PCN 1

ED-CM4SEN Release

EDA Technology Co., LTD

December 2023

RS485

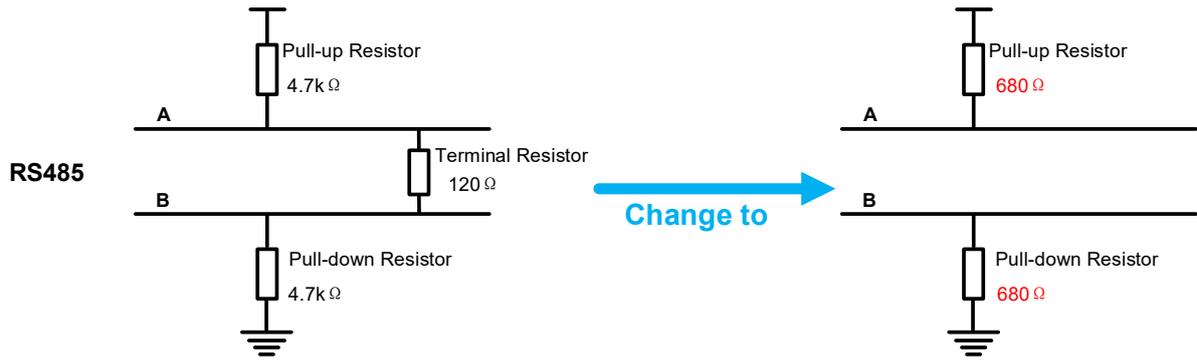
Changes	Results
Change the pull-up resistor and pull-down resistor of 4 RS485 circuits to 680Ω(The old version is 4.7kΩ).	• It will provide better compatibility and driving capabilities of RS485. • Compatibles with long distance and high baud rate transmission of RS485 signal. • Supporting to connect more RS485 devices on RS485 bus.
Remove the 120Ω terminal resistors of 4 RS485 circuits.

Original	Changed
Pull-up Resistor	4.7k Ω	680 Ω
Terminal Resistor	120 Ω	
Pull-down Resistor	4.7k Ω	680 Ω
